UNITED STATES OF AMERICA
NUCLEAR REGULATORY COMMISSION

License Amendment Request
No. 98-04

**REVISION OF TS 6.2.2g. AND 6.3 TO ELIMINATE REQUIREMENT FOR THE
OPERATIONS MANAGER TO HOLD A SENIOR REACTOR OPERATOR
LICENSE**

Figure 1

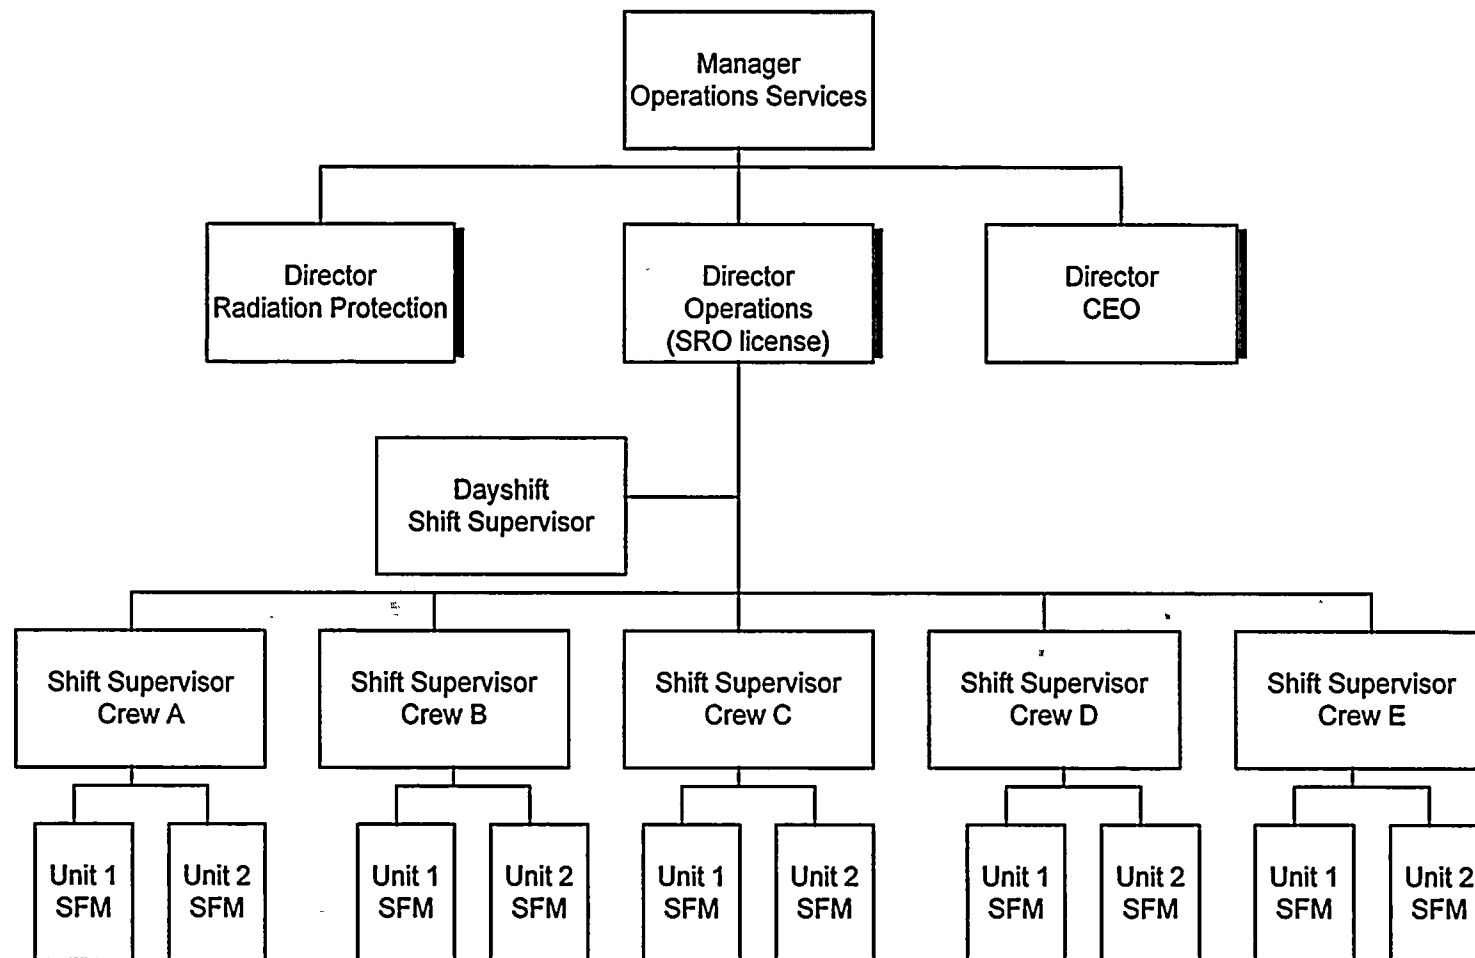
The current structure of the DCPP Operations Services organization is delineated in Figure 1. The Manager - Operations Services is responsible for the organizations that provide operational support to the

The five on-shift SSs currently report to the Operations Director (see Figure 1). The SSs have management responsibility for both units, act as the management liaison between their crew and management, and represent management when other more senior members of the Operations Section management team are not present (such as during backshift). The shift foreman of each unit reports to the SS. The proposed change would allow the on-shift SSs to report to an Operations middle manager that meets the requirements of ANSI/ANS 3.1-1993, Section 4.3 if the Operations Director does not hold an SRO license for DCPD (see Figure 2).
